Atlantic Crossing

CLASS II MODIFICATION 2019 - 8.2.2019

CLASS II MODIFICATION SUPPLEMENT 10.25.2019

PLAZA SUPPLEMENTAL EXHIBITS

BLDG VI ELEVATIONS

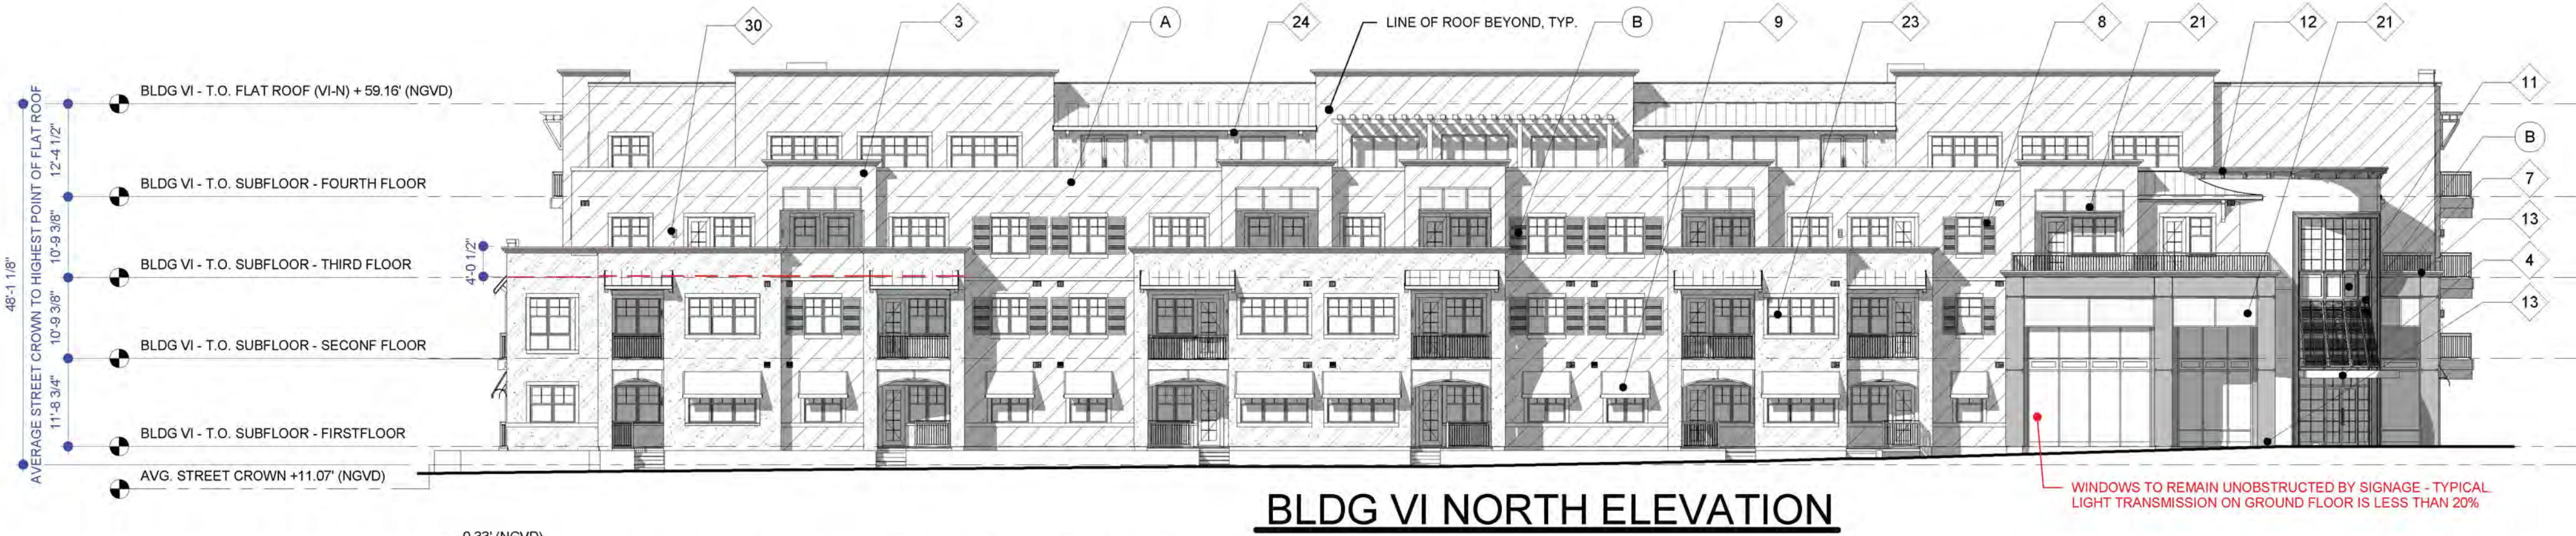
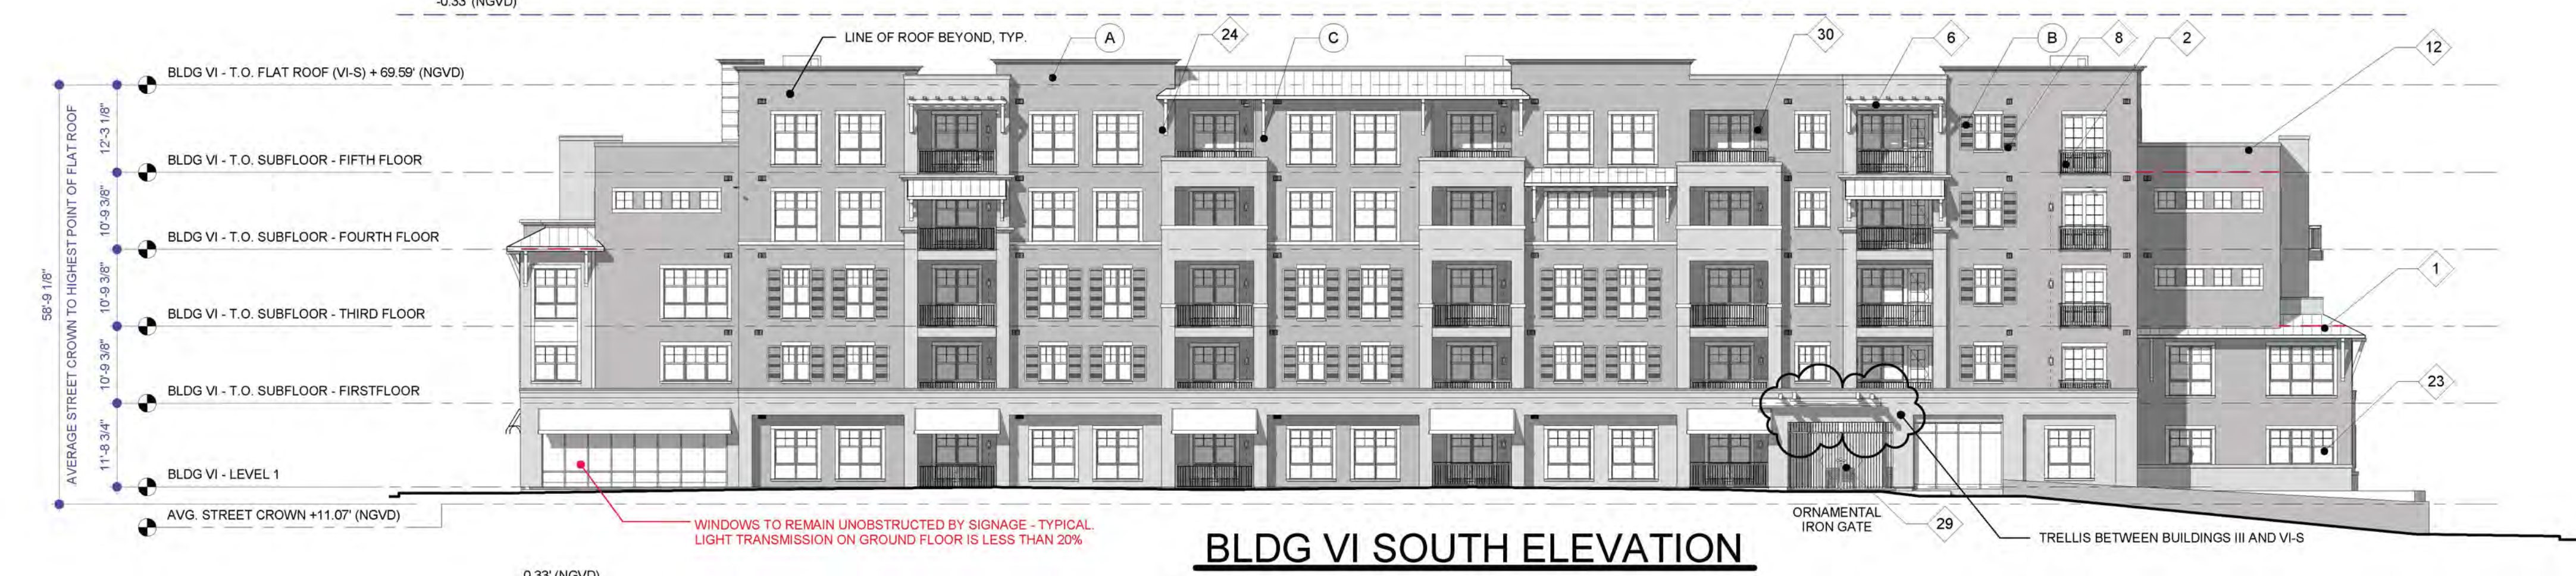
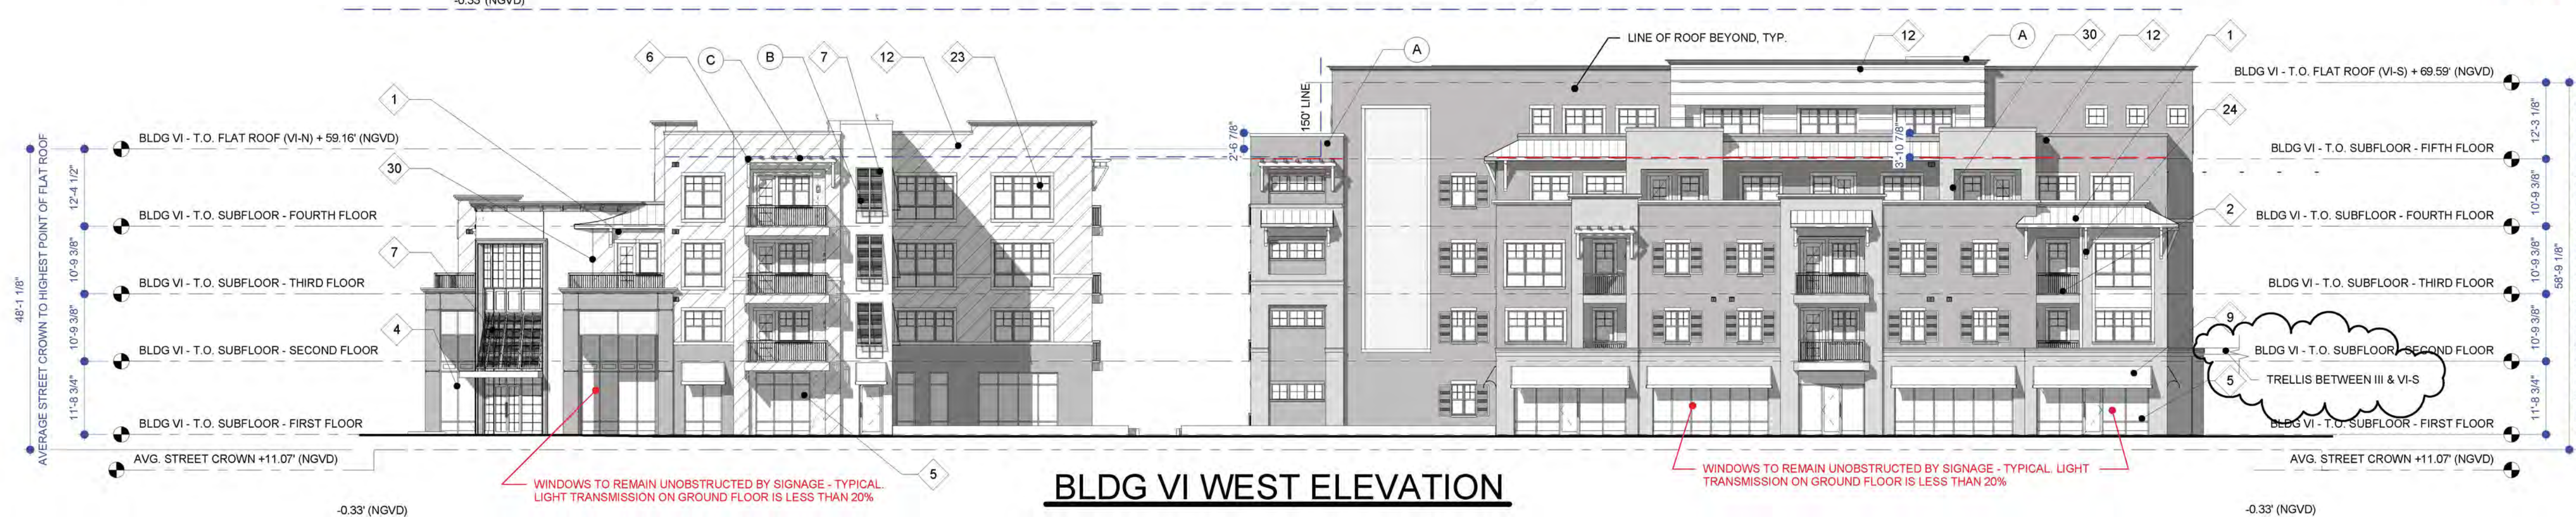
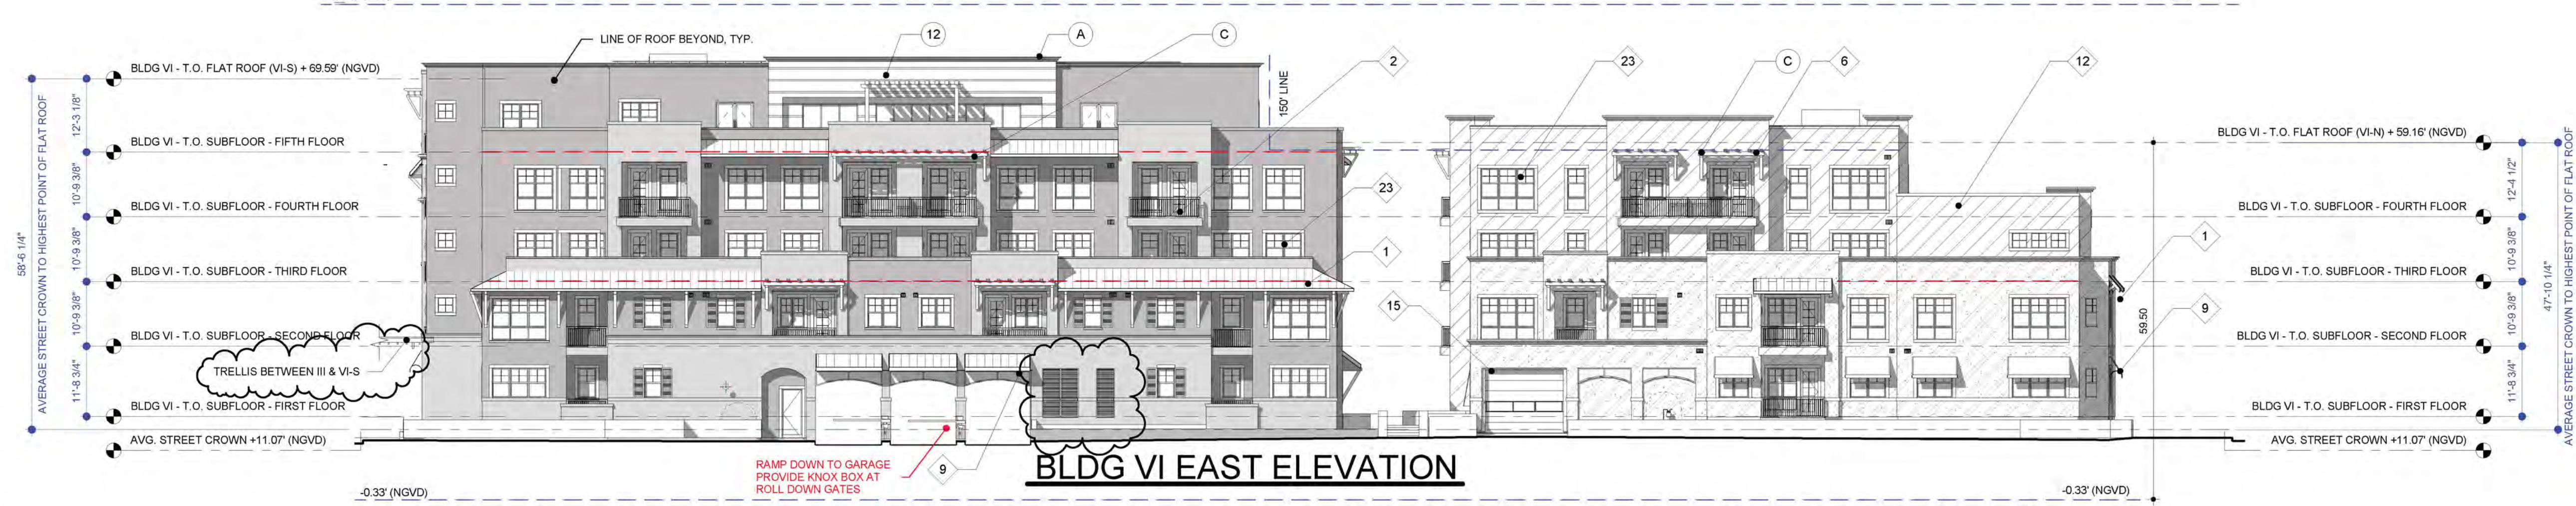
RESPONSE TO 2.12.14 STAFF COMMENTS
• WINDOWS OF THE BUSINESSES AND OFFICES REMAIN UNOBSTRUCTED BY SIGNAGE
• LIGHT TRANSMISSION FOR GROUND FLOOR GLASS AREA TO BE NO GREATER THAN 20%
• KNOX BOXES TO BE PROVIDED AT ROLL DOWN GATES
• ADJUSTED METAL AWNINGS AND ADDED MORE SHUTTERS

SETTLEMENT MODIFICATION 4.21.2017
• RELOCATED ENTRY TO PARKING GARAGE
• ADJUST EAST AND SOUTH DUE TO PARKING GARAGE ENTRY RELOCATION

ARCHITECTURAL ELEVATION REVISIONS 7.19.2018
GENERALLY REVISE ELEVATIONS TO BE MORE CONSISTENT WITH MASONRY MODERN, INCLUDING:

- STRENGTHENING PEDESTRIAN SCALE OF ENTRY TO LEASING (NORTH-WEST CORNER)
- ENHANCED HORIZONTAL DETAILING AT BASE - ADDED ROOF FORMS, CONSOLIDATED COLOR, MINIMIZED TALL SLENDER VERTICAL FORMS
- ENHANCE DETAILING AT BUILDING CAP
- ENHANCE DETAILING AT BUILDING CORNERS

CLASS II MODIFICATION 8.2.2019
• ADD TRELLIS BETWEEN III & VI-S

2 PLAZA ACCESS TO GARAGE - SHELL CONCEPT BEFORE
1/8" = 1'-0"

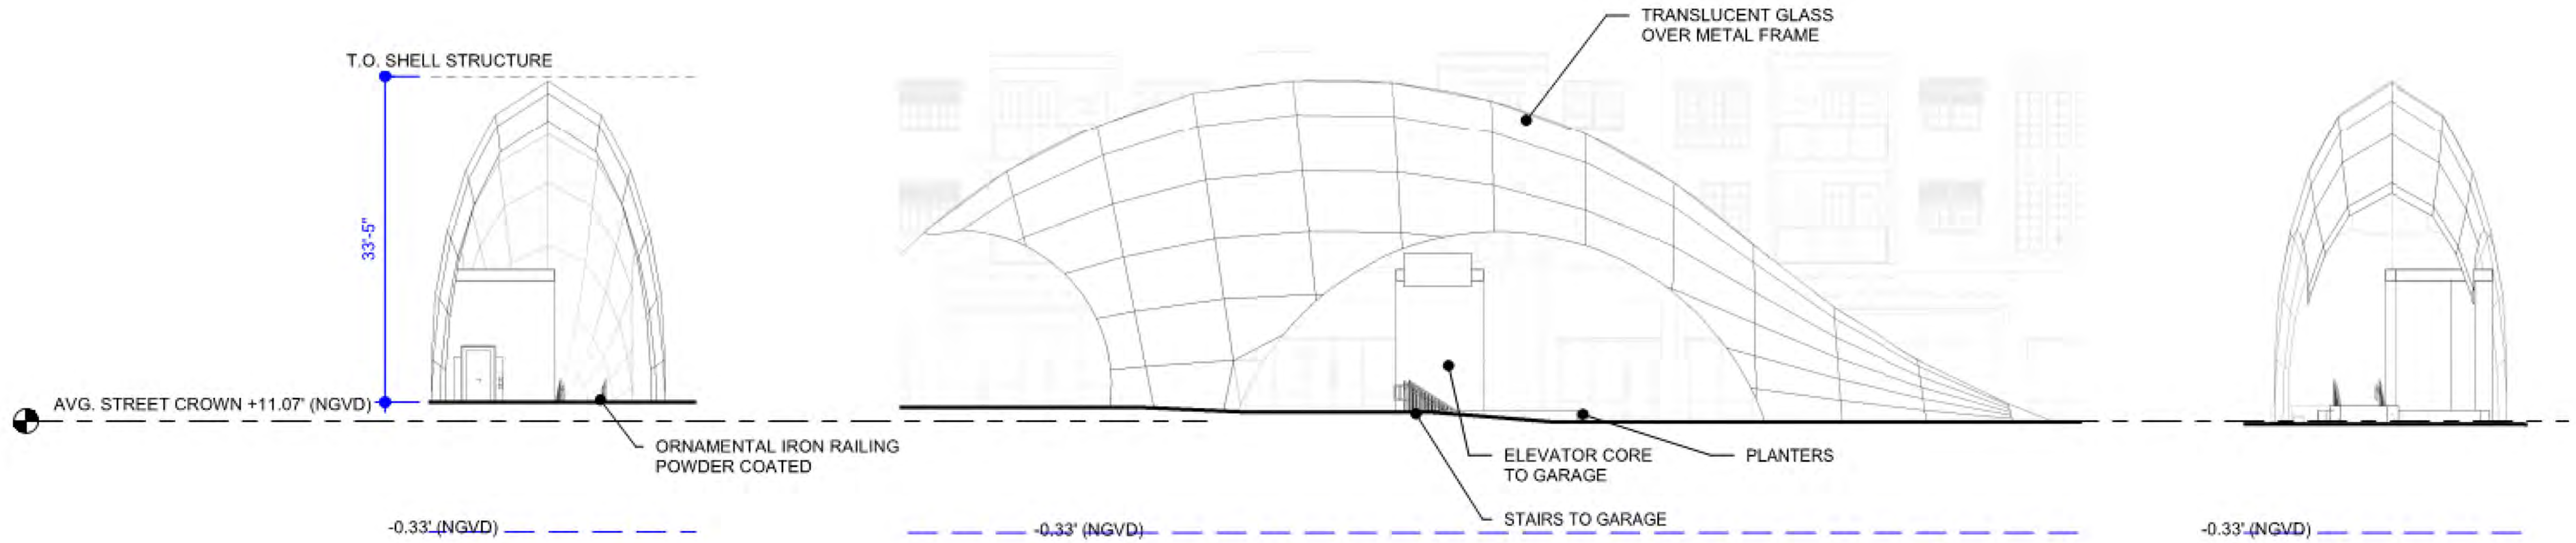
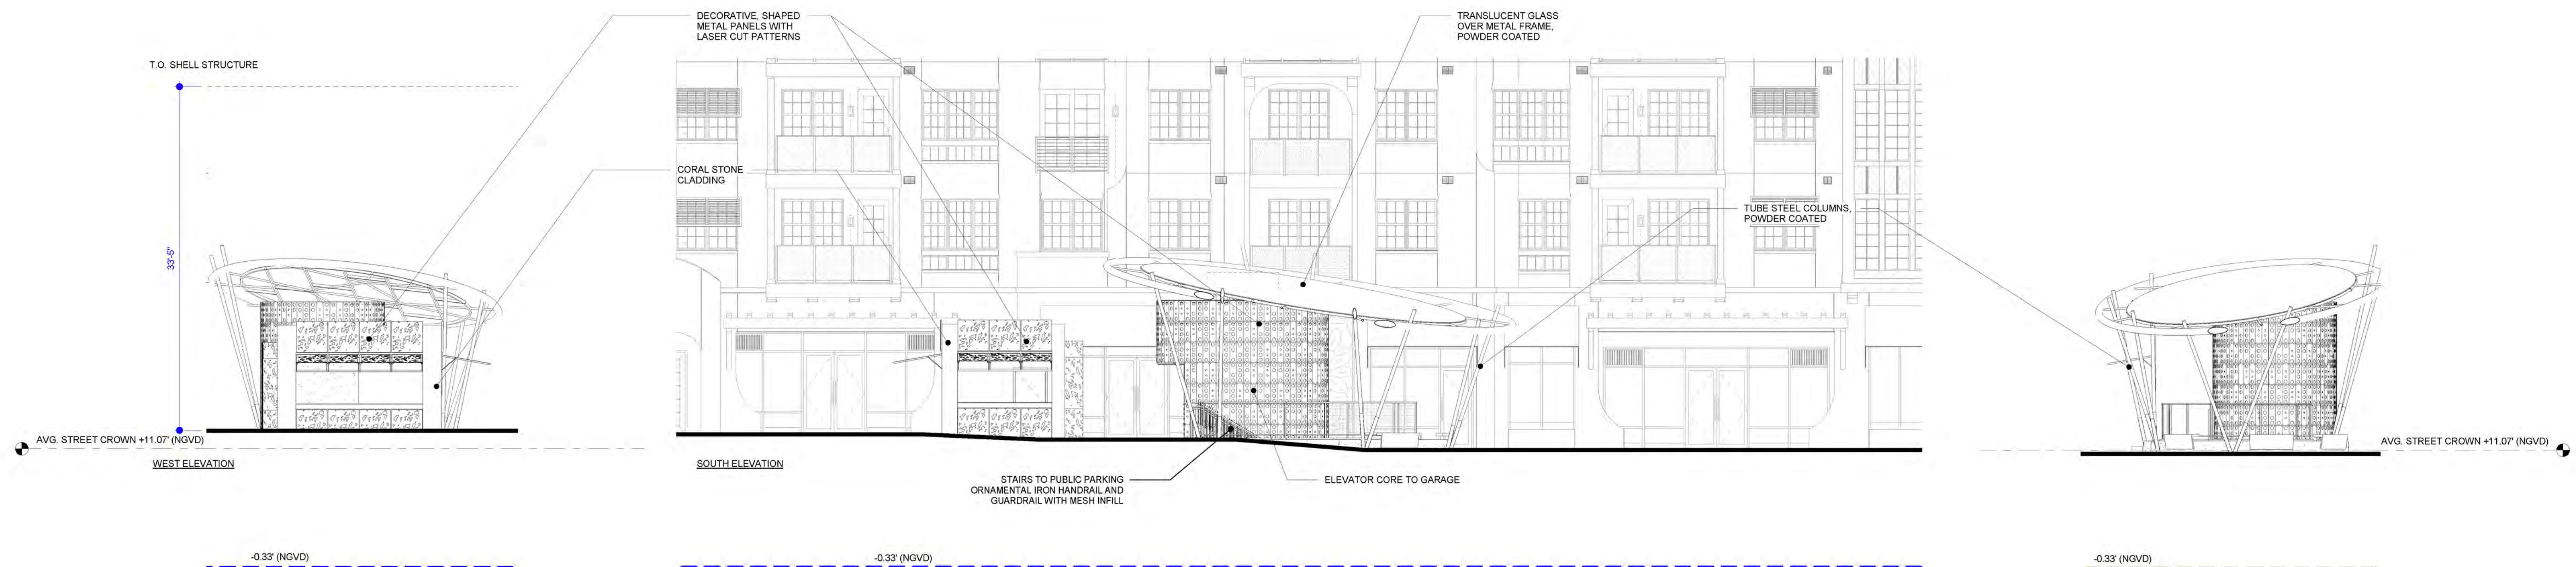
1 PLAZA ACCESS TO GARAGE - AFTER
1/8" = 1'-0"

1 BUILDING VI-S MAILROOM ENTRY - BEFORE
1/4" = 1'-0"

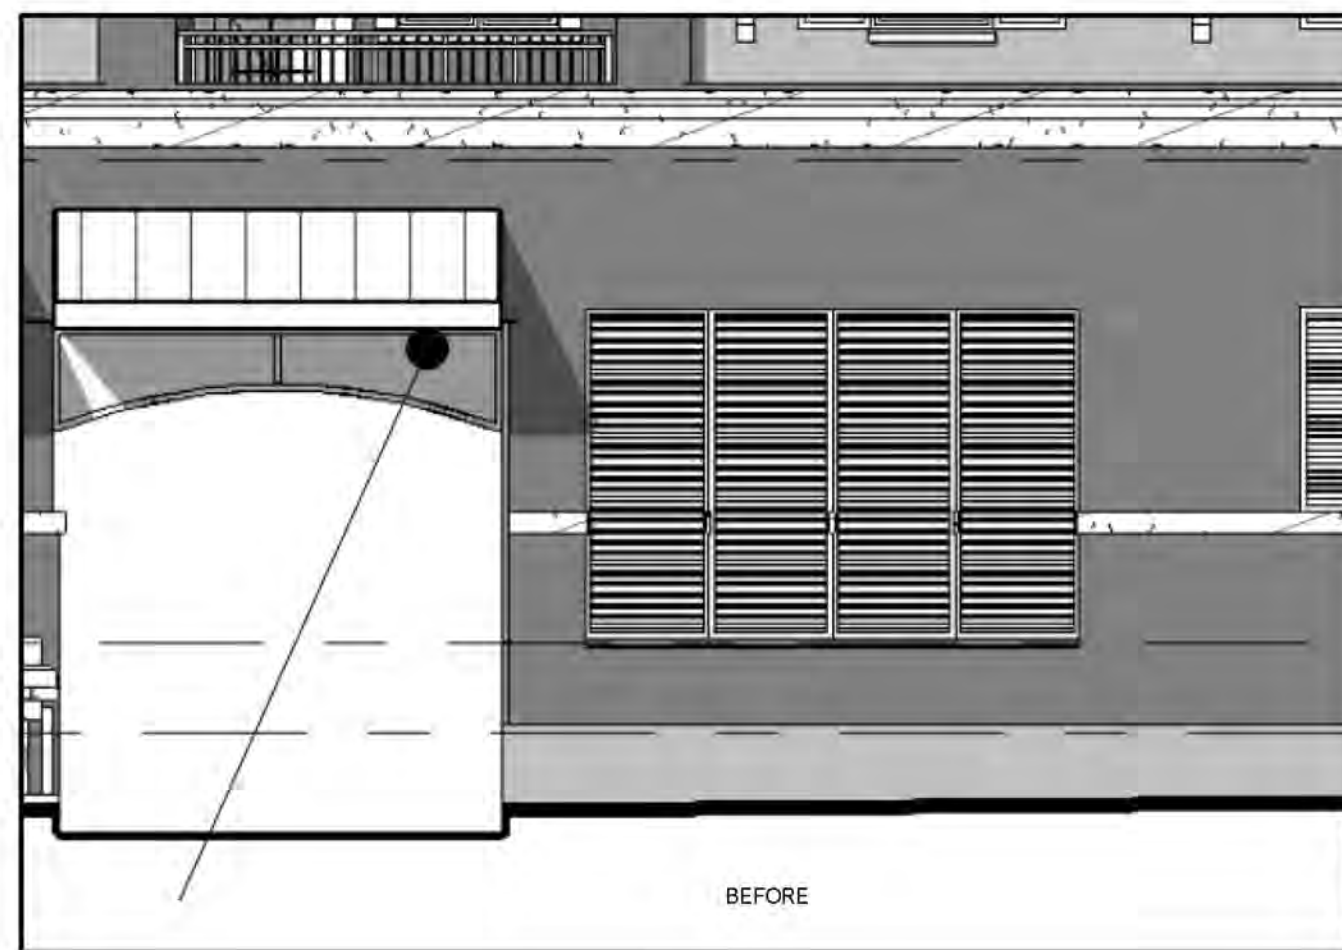
ADDED TRELLIS TO ORIENT
PEDESTRIAN CROSSING. ALSO
PROVIDE TRAFFIC CALMING

ADDED WINDOWS (RELOCATED
FIRE PUMP ROOM TO BUILDING III)

2 BUILDING VI-S LOUVERS AT WALL ADJACENT TO GARAGE RAMP
1/4" = 1'-0"

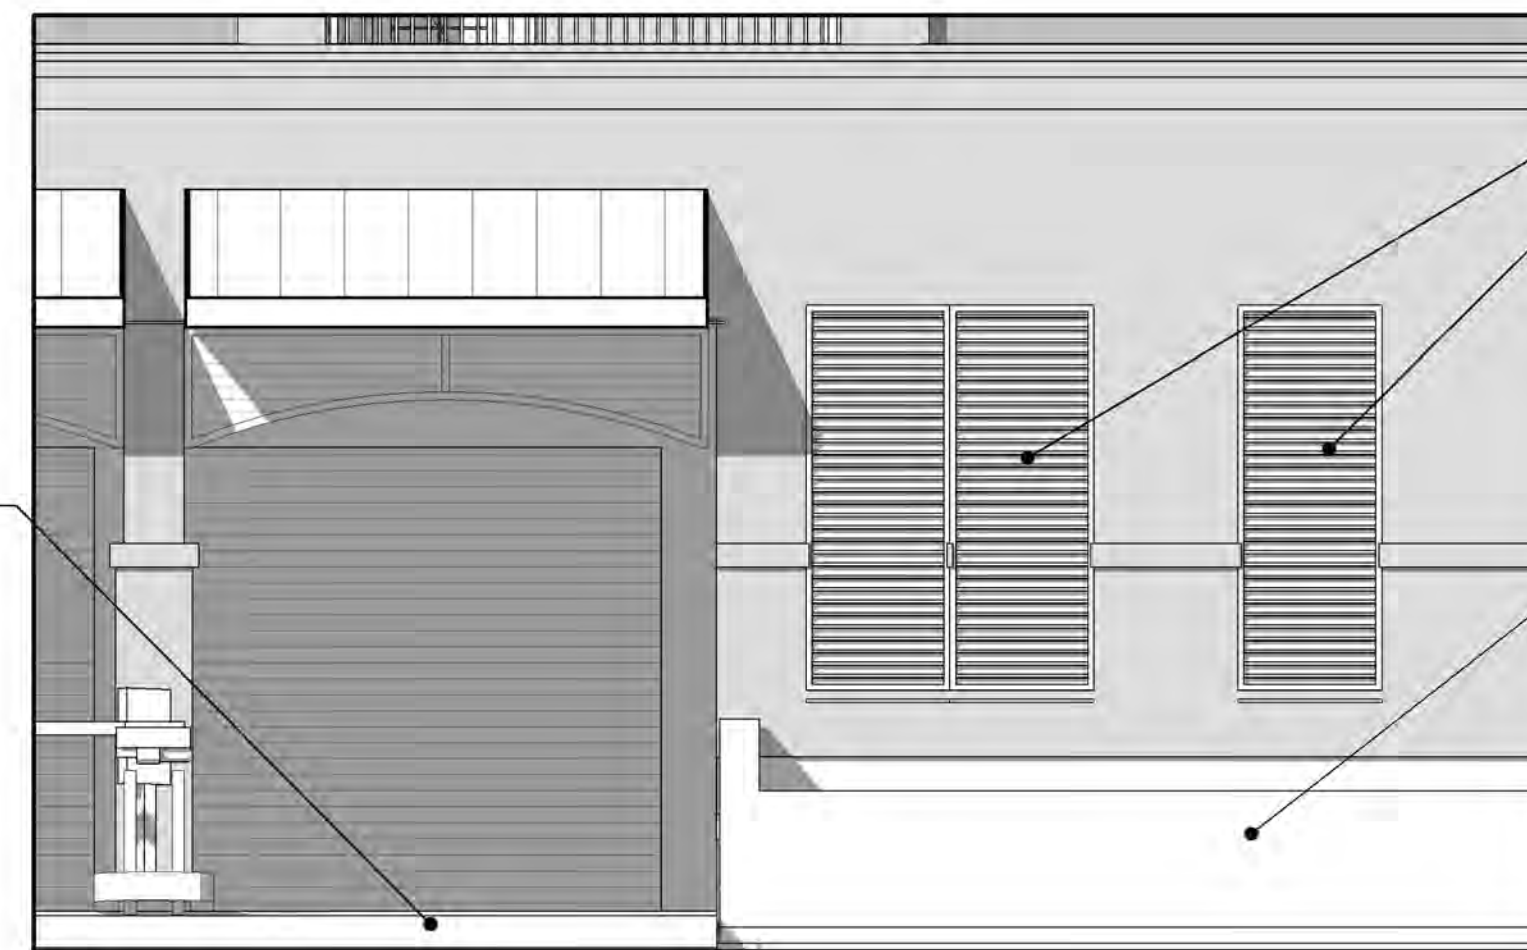
CORRECTED LEVEL OF
ENTRY AT GARAGE RAMP

MODIFIED COMPOSITION OF LOUVERS

DETAILED TALLER PLANTER WALL
